**Re: Minor Project Refinement No. 11 for the TL 6975 San Marcos to Escondido Project**

## TL6975 San Marcos to Escondido 69 kV Project CPUC Minor Project Refinement Form

**TL6975 SAN MARCOS  
to ESCONDIDO PROJECT**  
**MPR 11**  
**Additional Temporary Work Area**  
**San Diego County, CA**

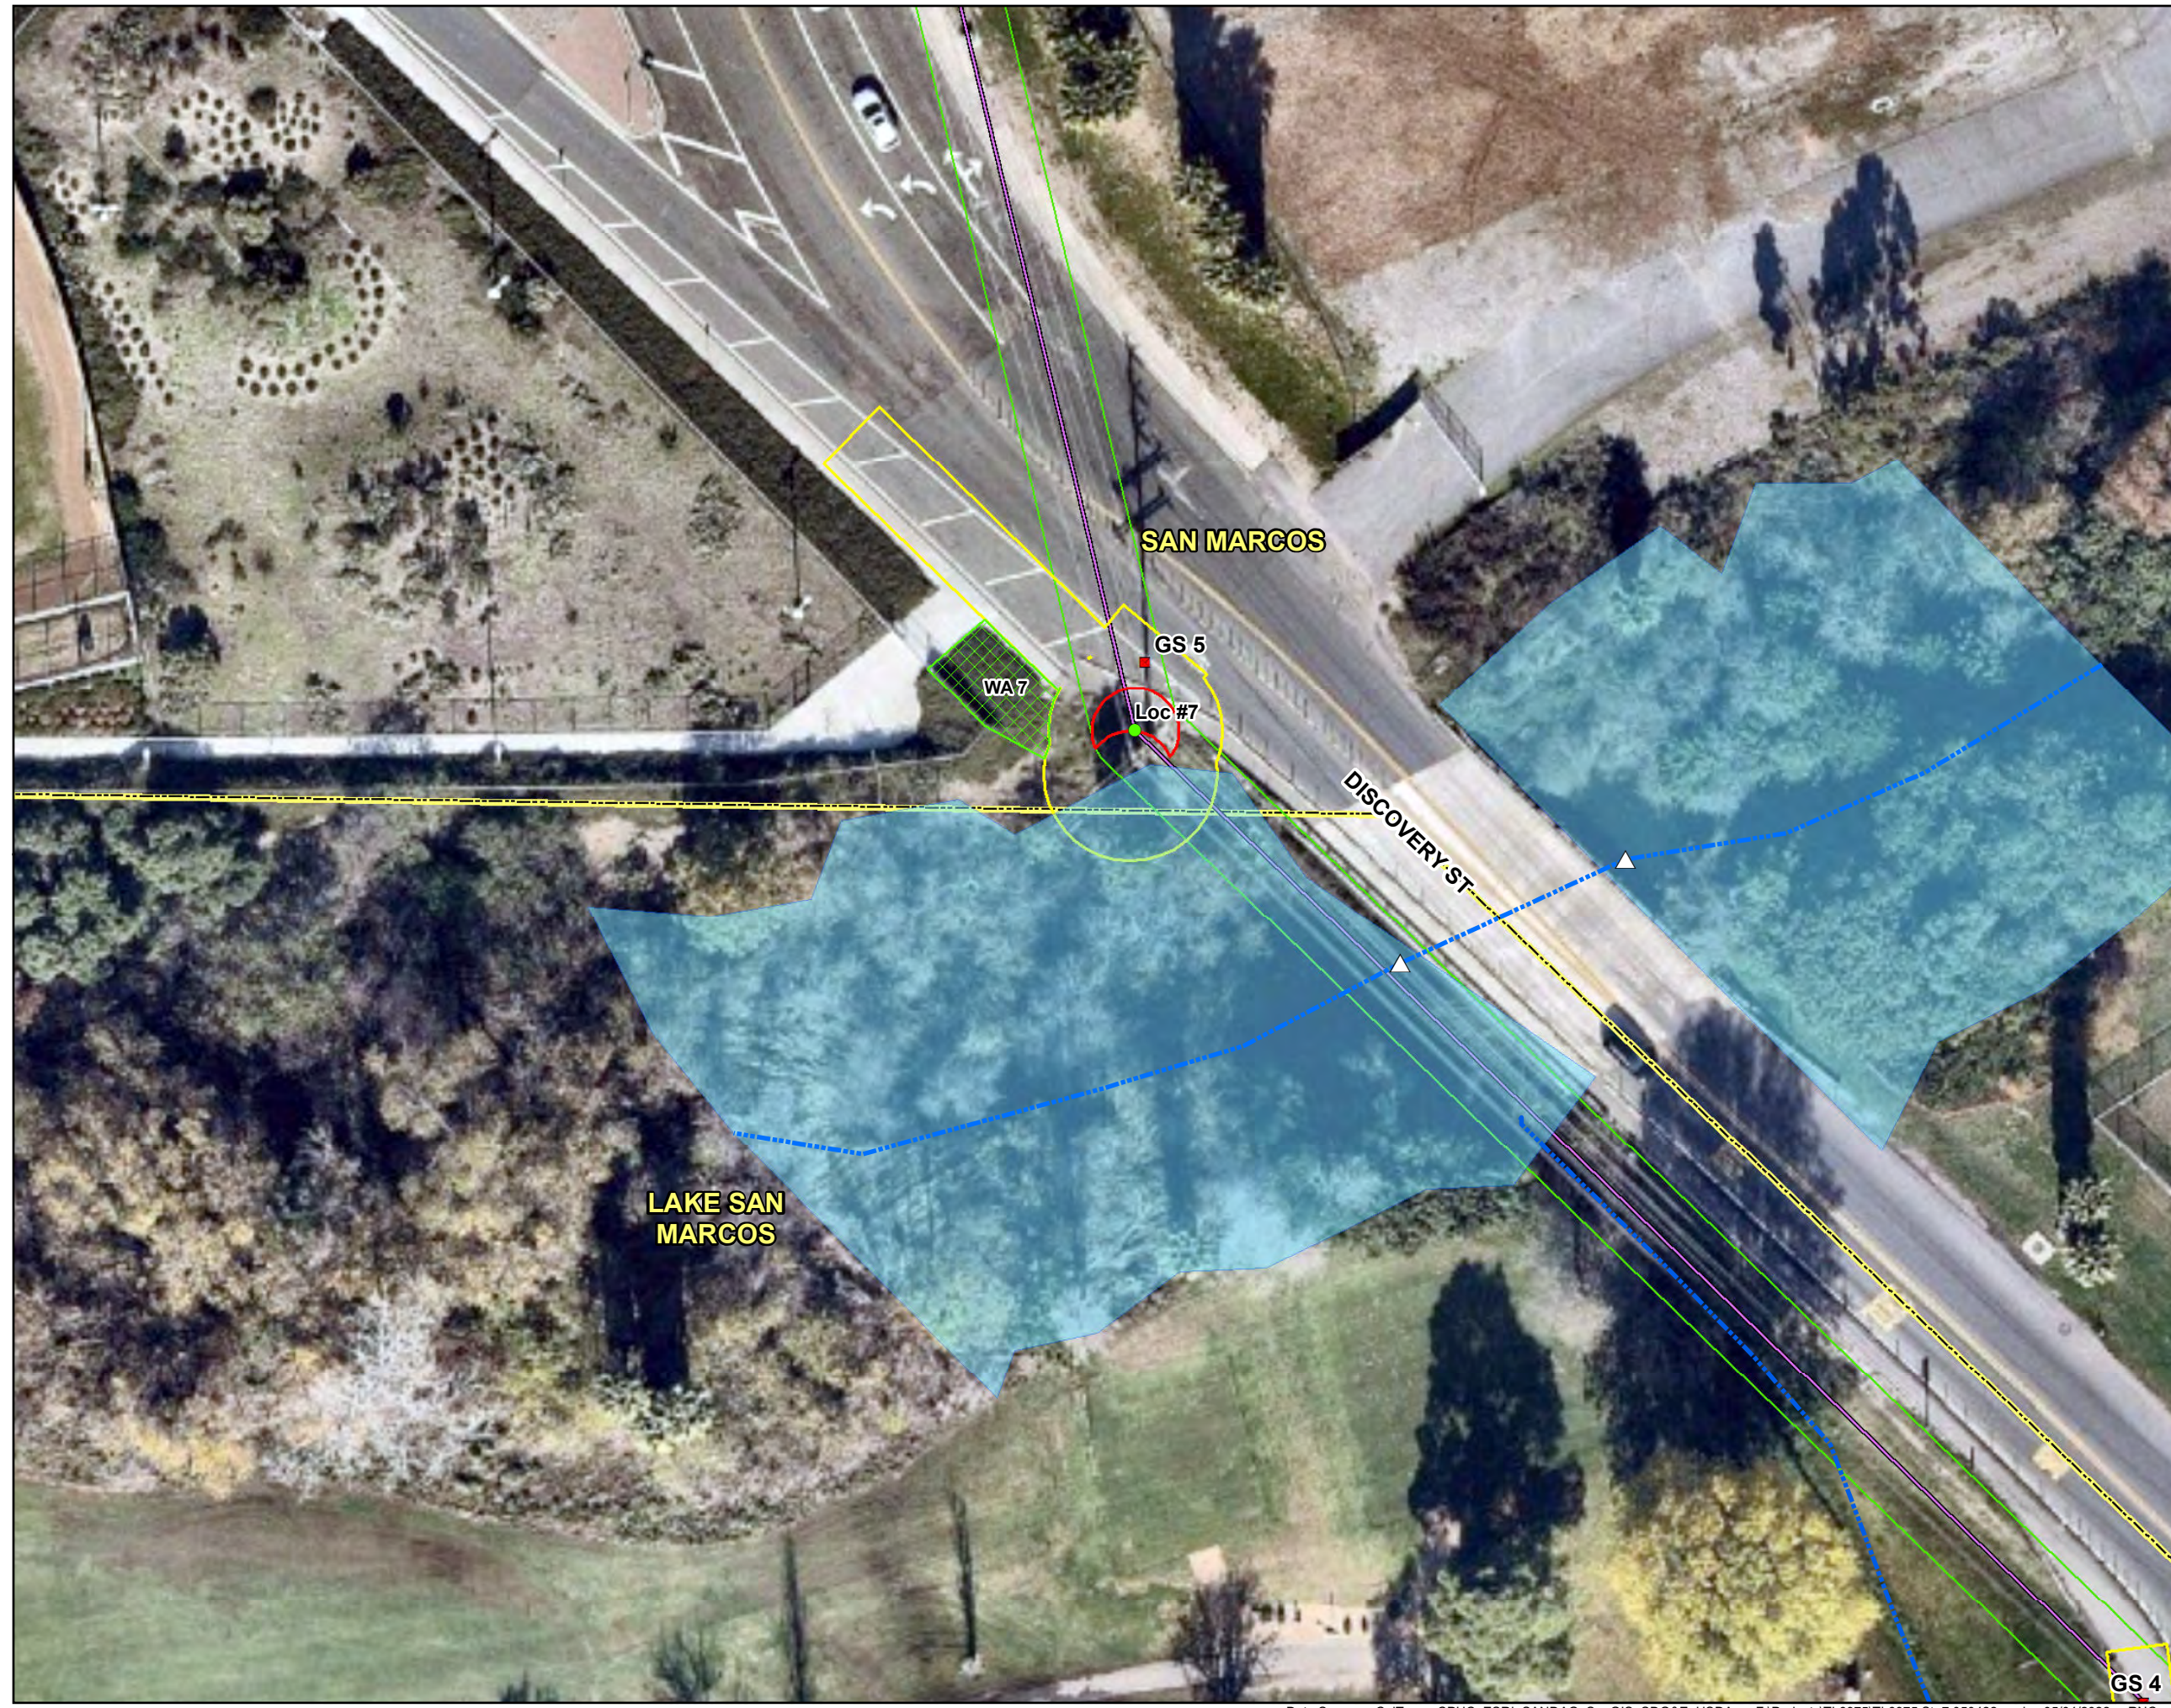
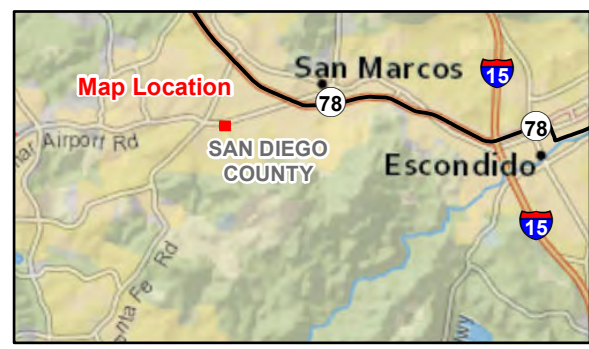
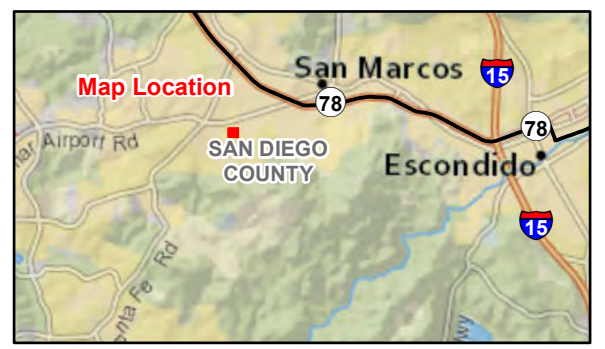
San Diego Gas and Electric (SDG&E) is requesting approval of MPR-11 for additional work areas to facilitate pole and conductor installation activities at Locations 2.1, 3 and 7 on the TL6975 San Marcos to Escondido Project (Project). See **Attachment B, MPR-11 Figure** and **Attachment C, MPR-11 Site Photographs**, for an overview of the proposed MPR-11 work areas.

- **Location 2.1 Additional Work Area (WA 2.1):** WA 2.1 is a circular work area with a 10-foot radius around Location 2.1. Location 2.1 is changing from a designation of “No Work/Information Only” (as shown in the NTP-1 Mapbook) to “Overhead Work” as overhead fiber work will likely be required at this location. The overhead work would be performed from the street using a bucket truck. The location of the bucket truck and associated traffic control will be determined in the forthcoming right-of-way (ROW) Permit and Traffic Control Plan issued by the County of San Diego. No vegetation trimming is anticipated within WA 2.1.

- **Location 3 Additional Work Area (WA 3):** WA 3 is immediately northeast of Stringing Site 01 and southeast of Location 3 on SDG&E property. This expanded work area will be utilized to position equipment (water truck, drill rig, etc.) during pole installation and wire pulling activities at Location 3. Within WA 3 and along the perimeter of San Marcos Substation, there is landscaping planted by SDG&E comprised of African sumac trees, juniper shrub understory, and mature olive trees. Three African sumac trees and the juniper shrub understory will need to be removed (grubbed), and two mature olive trees will need to be trimmed (see **Attachment C** for an overview of vegetation). The African sumac tree removals would take place using a chainsaw and a skid steer or similar equipment. Stormwater Pollution Prevention Plan (SWPPP) BMPs would be installed to prevent off-site sedimentation in areas where the vegetation is being removed or grubbed.

- **Location 7 Additional Work Area (WA 7):** WA 7 is located west of Location 7 immediately adjacent to the approved work area for Location 7. The additional work area will be utilized to stockpile spoils from the foundation excavation for the pier foundation at Location 7. A silt fence will be installed around the perimeter of WA 7 to protect from any runoff into the nearby jurisdictional aquatic feature. The ornamental acacia shrub within WA 7 will be trimmed down to create space for the spoils stockpile. SDG&E has received approval from the property owner (San Marcos High School) to trim the ornamental vegetation within WA 7. Vegetation trimming would be completed with both hand tools and a skid steer with a mower deck and would be no less than 4 inches above the ground to maintain the root structure and seed bank per the SDG&E Natural Communities Conservation Plan (NCCP) Operational Protocol No. 36 (Section 7.1).

**Photograph 2:**

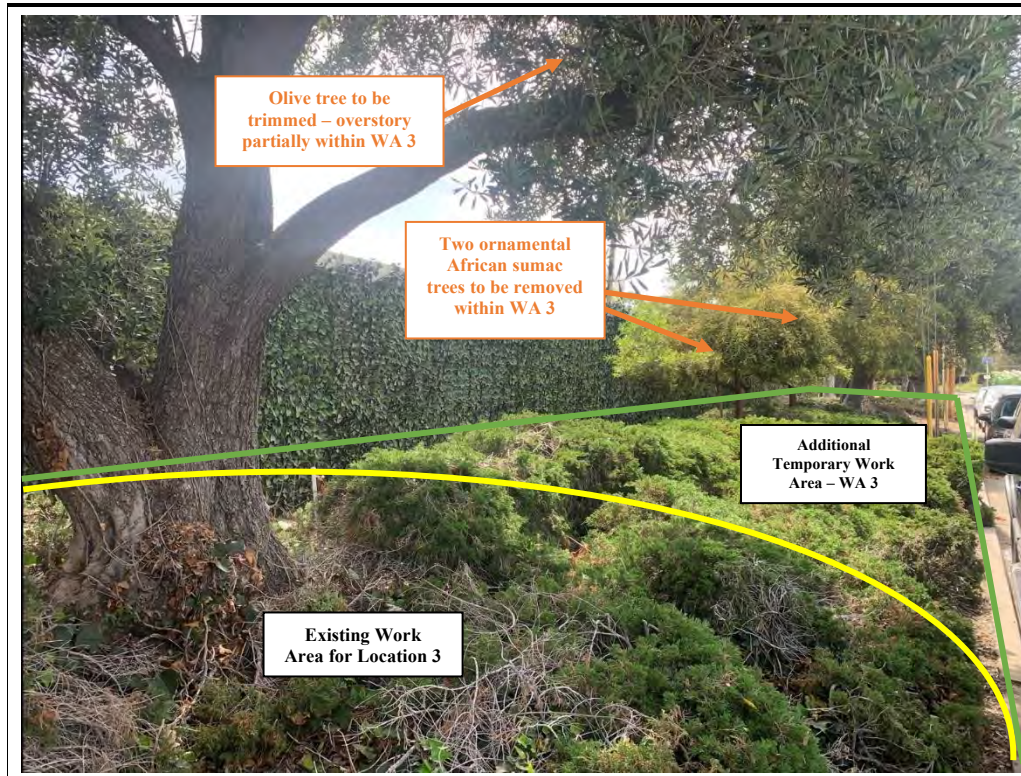
View of the additional temporary work area at Location 3 (WA 3) and Stringing Site 01. An overview of vegetation removal at this location is shown on Photographs 3-5. Facing: SE.

**Photograph 3:**

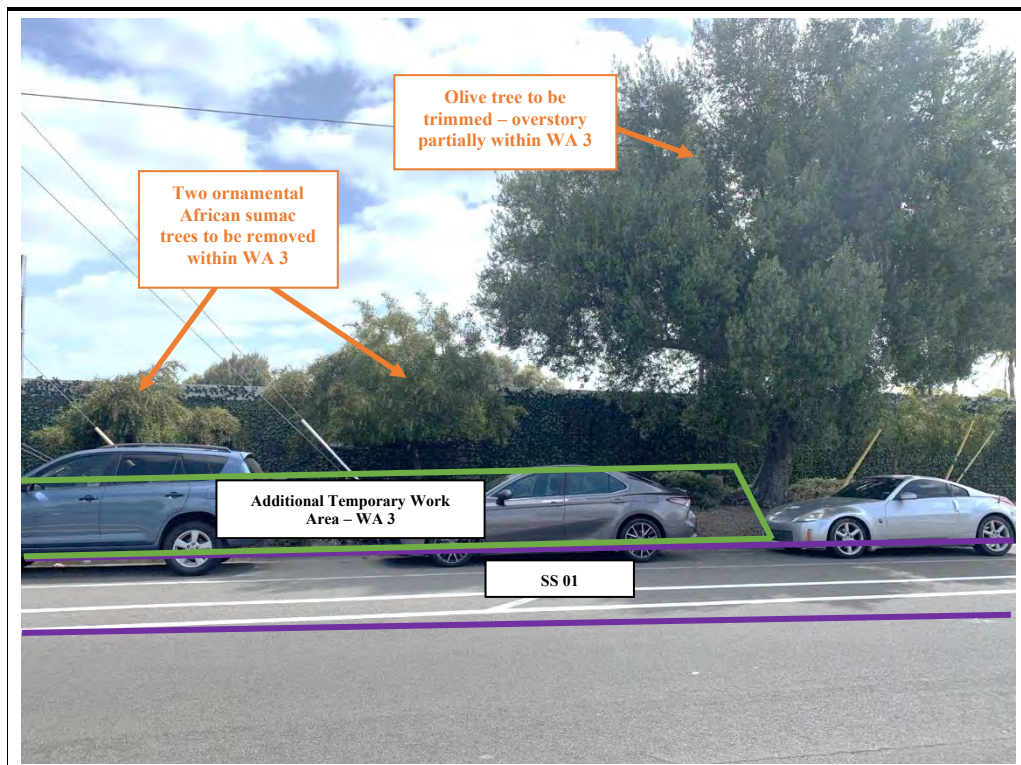
View of the existing work area for Location 3, the proposed WA 3 as well as two of the African sumac trees proposed for removal and one of the olive trees proposed for trimming. The juniper shrub understory will also be removed throughout WA 3. Facing: East.

**Photograph 4:**

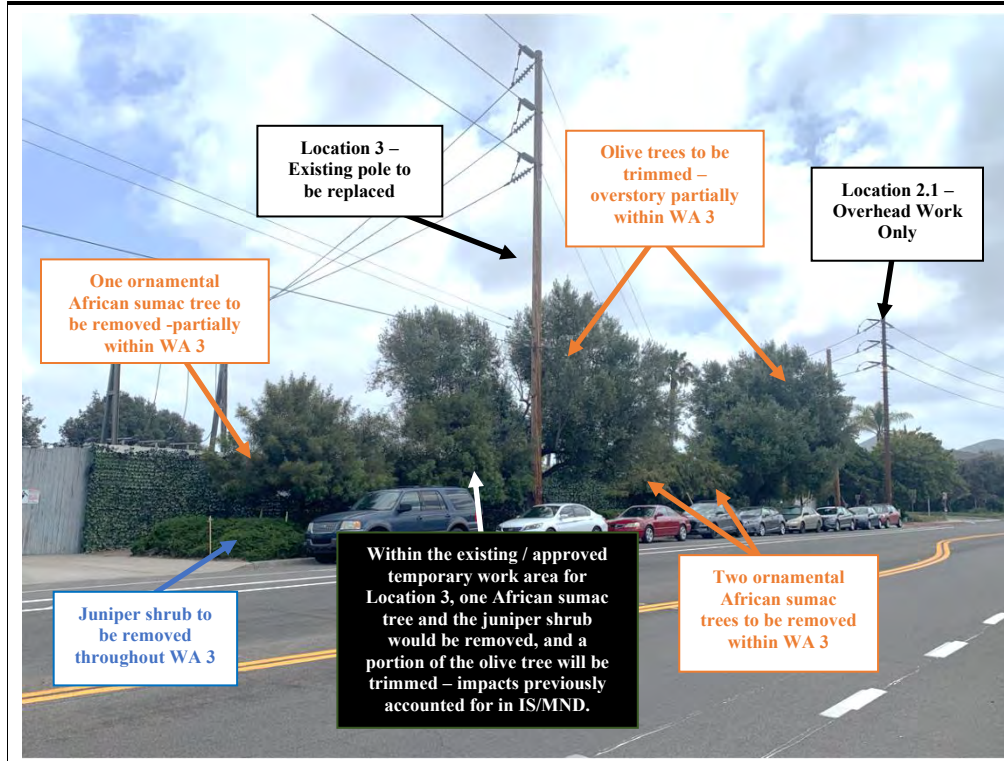
View of the proposed WA 3, Stringing Site 01 as well as two of the African sumac trees proposed for removal and one of the olive trees proposed for trimming. The juniper shrub understory will also be removed throughout WA 3. Facing: East.
